ADDENDUM NO. 1

BUILDING PERIMETER SECURITY AT THE DAVID L. LAWRENCE CONVENTION CENTER

PRE-BID MEETING, NOVEMBER 18, 2020, 2:00 PM

1. QUESTIONS:

QY-3

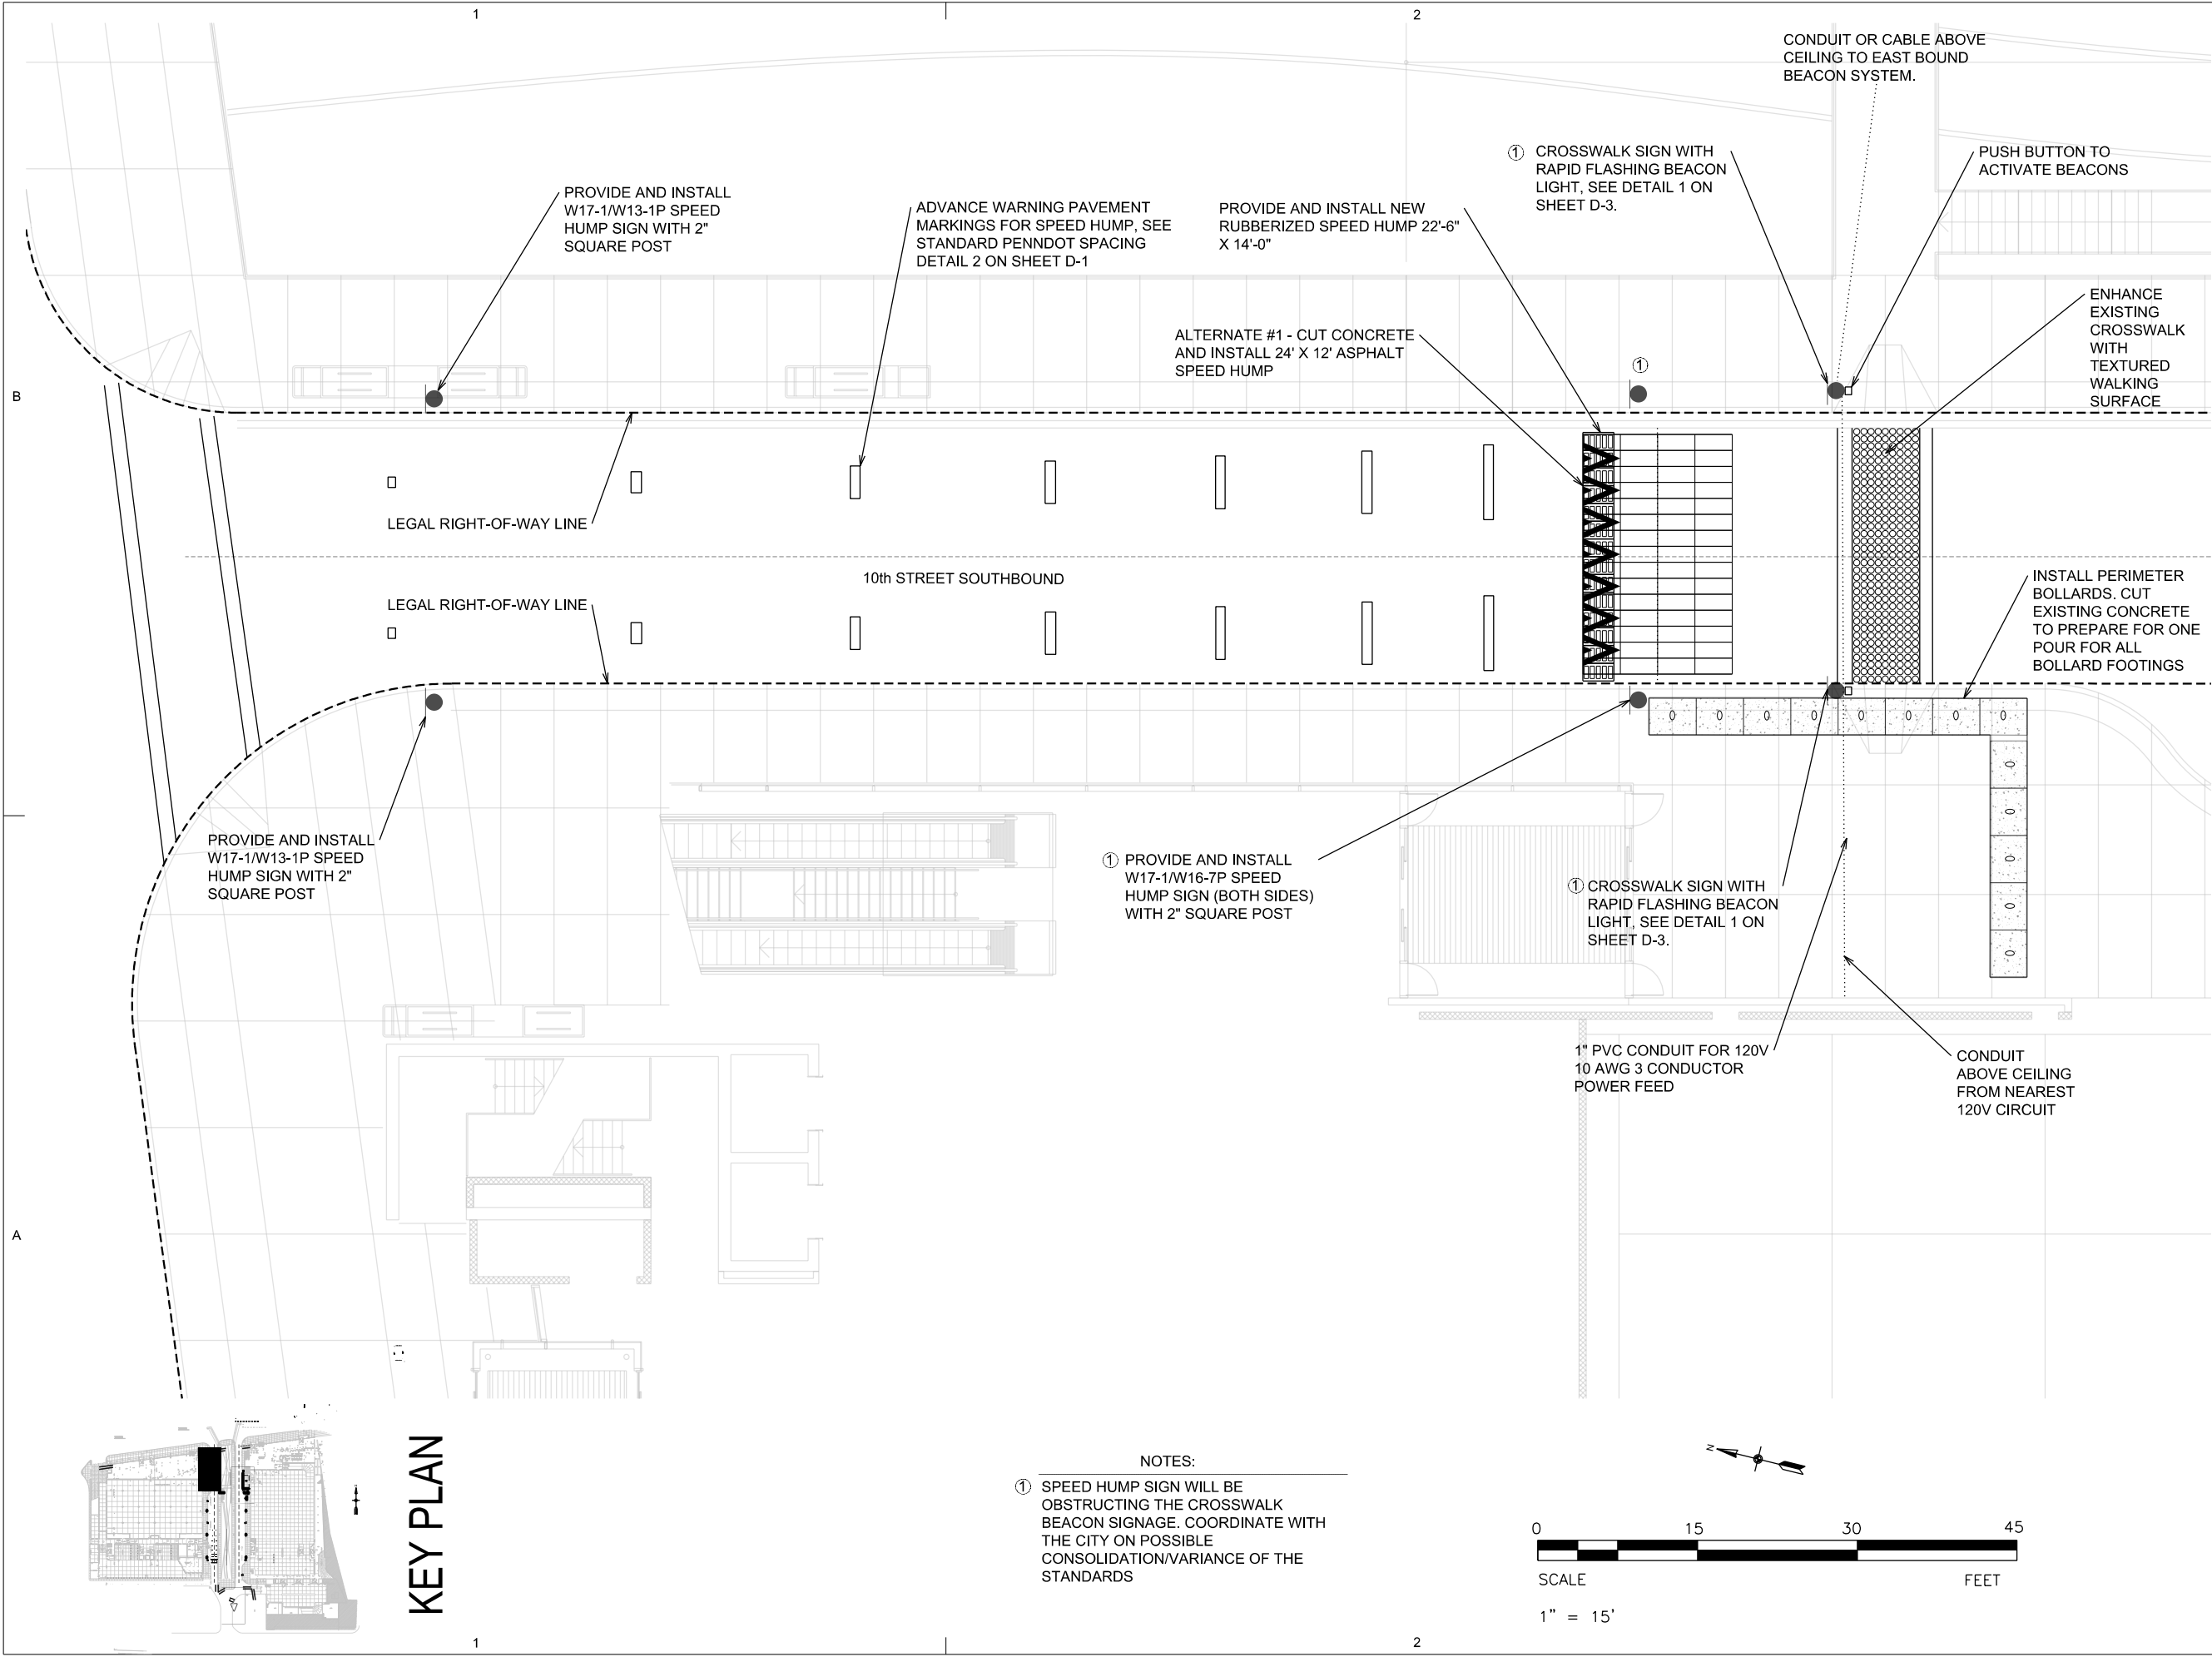
- z. Drawing QY-3 and QY-5 show required installation of “bollards” or “anti-ram bollards” on each side of ADA ramps, appearing to be a total of 6 units. Will these also be “Equal to Truckstopper 3 K4 rated bollards by Tymetal Corporation”?**

- i. There is a total of (12) for ADA ramps and these shall be the K4 Rated bollards.
- aa. Page 34 75 13-4, Section 2.5 – Vehicle Barrier: It was discussed at the pre-bid meeting yesterday that this equipment/section had been removed from the original bid specification. Will this component be bid separately in a later bid specification?**

QY-4

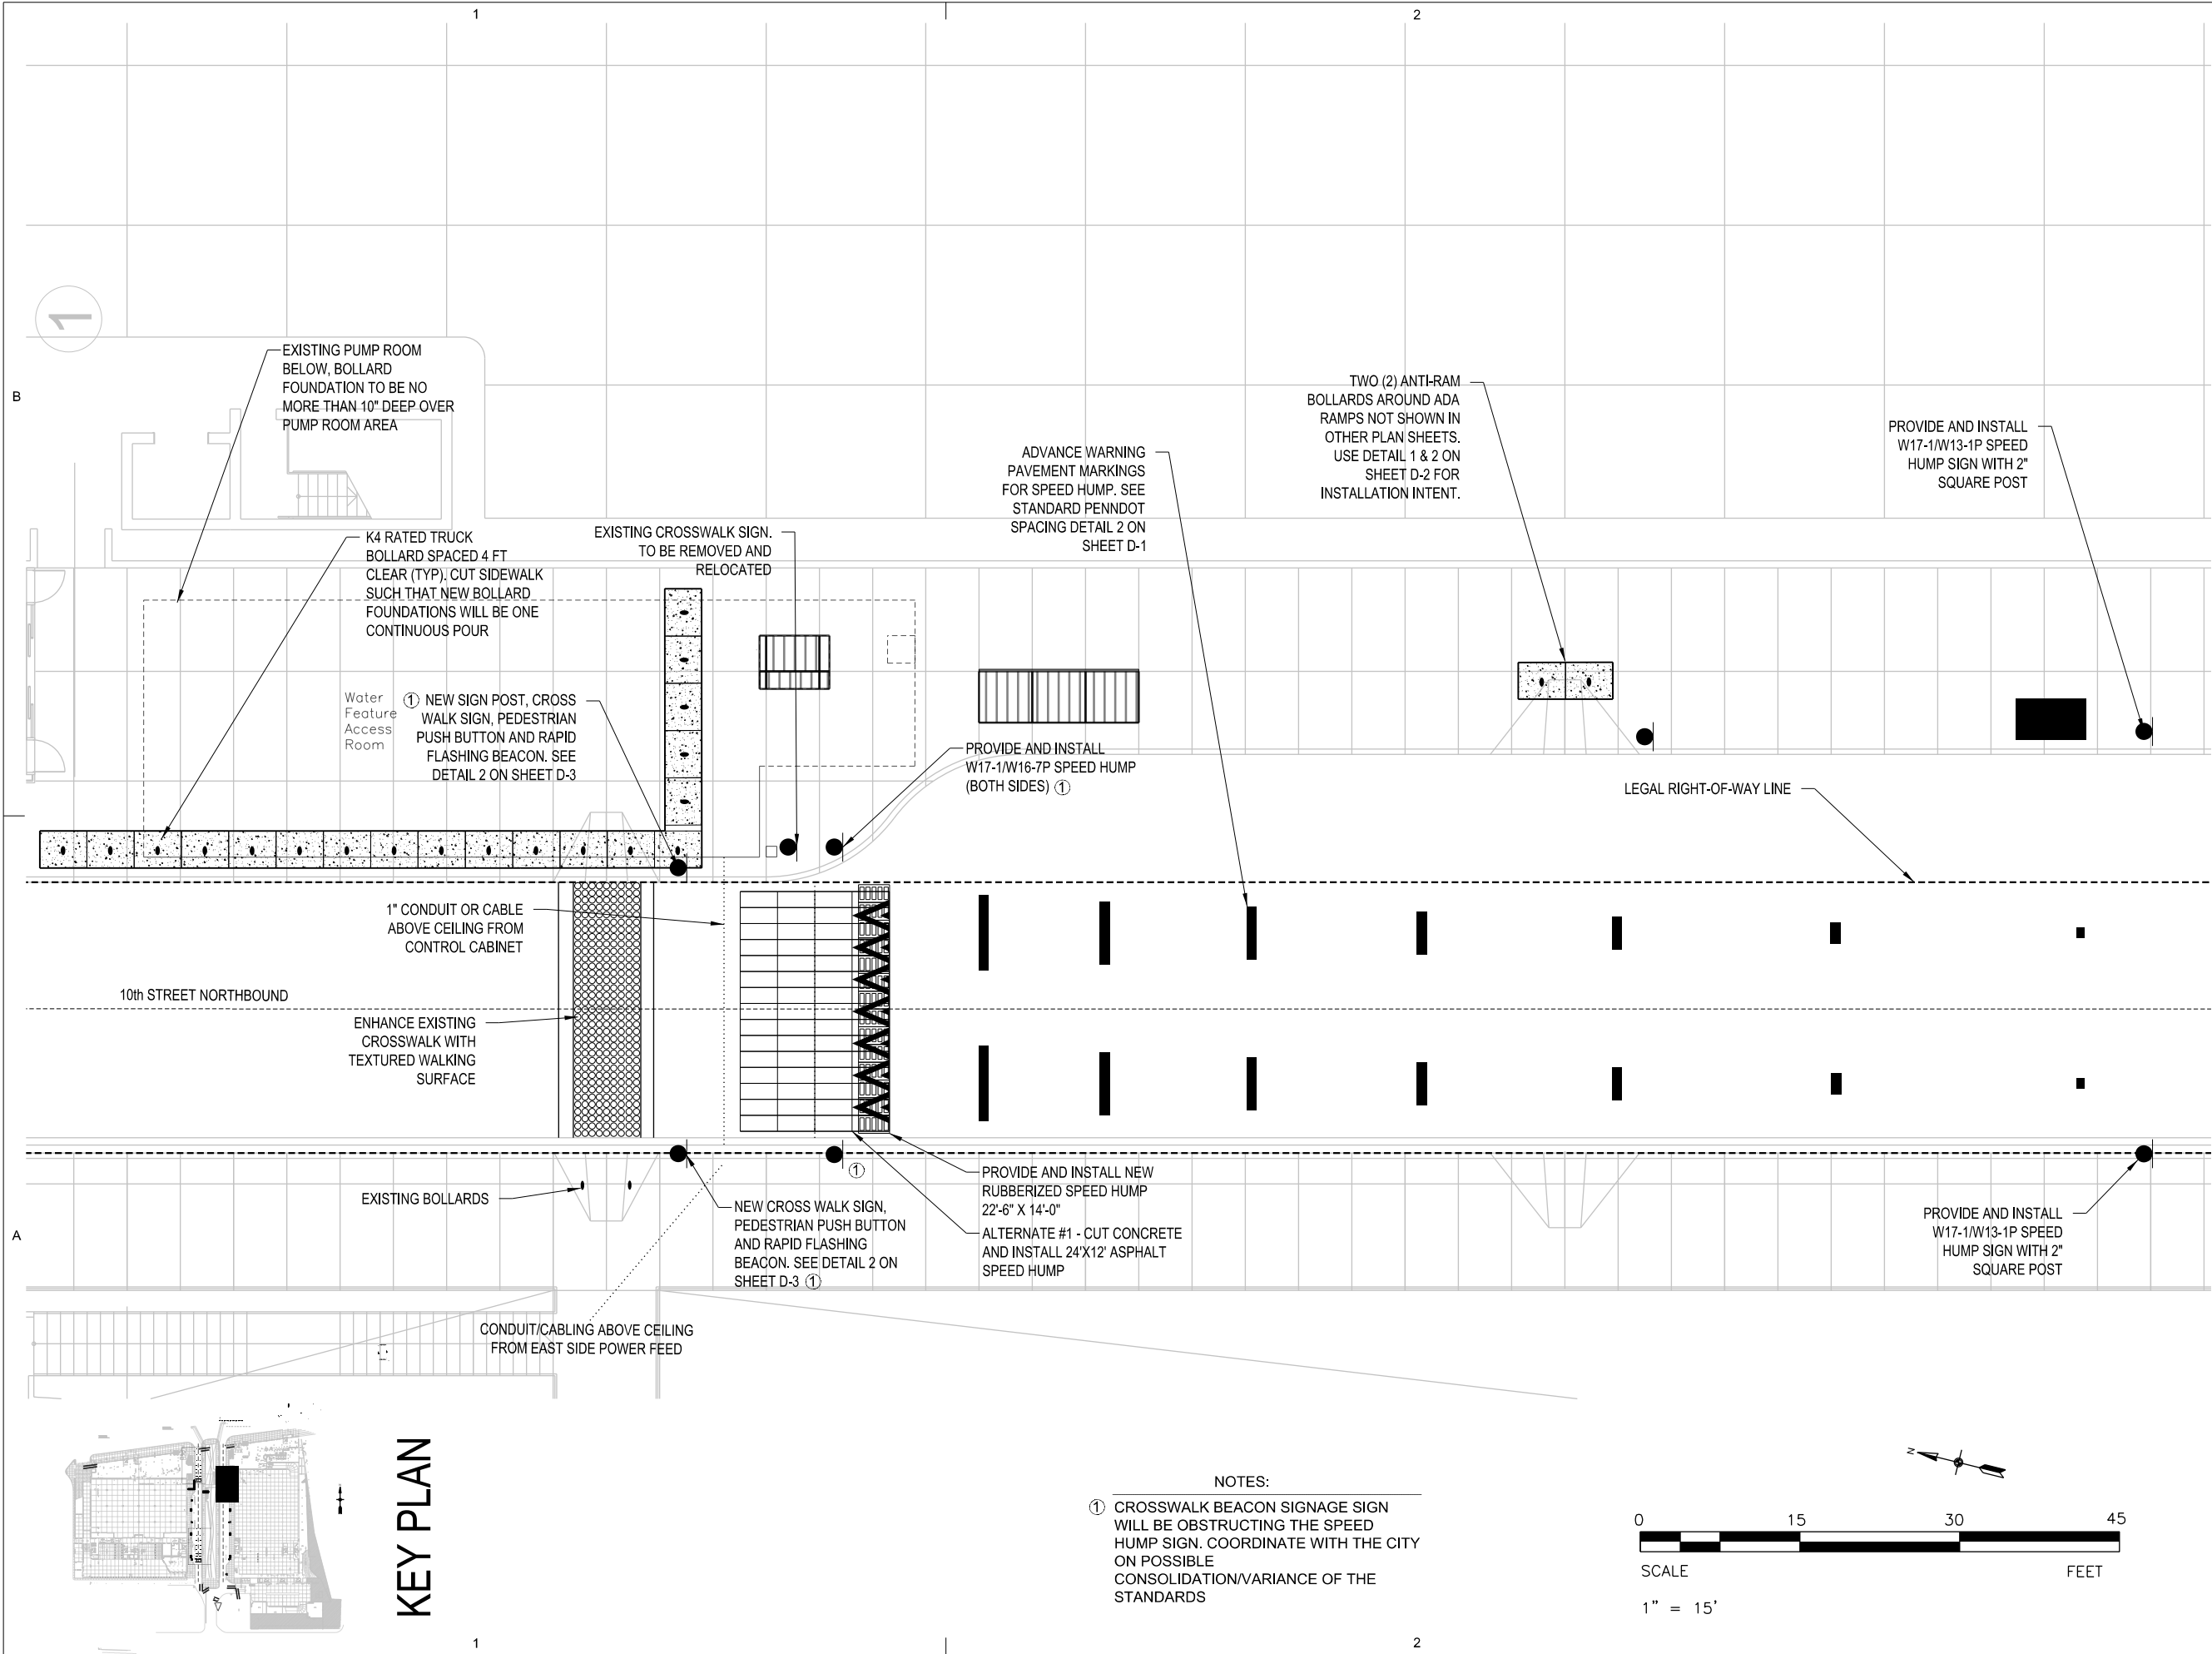
- y. Drawing QY-4 shows 13 bollards and QY-5 shows 19 bollards for a total of 32 bollards. However, the table on Drawing D-2 notes a required quantity of 44 bollards. Please specify the intended location of the additional 12 bollards?**

- i. Please see QY-1 for overview of all locations
 - 1. (19) at East Lobby
 - 2. (6) at ADA ramps of East Side
 - 3. (13) at West Lobby
 - 4. (6) at ADA ramps of West Side
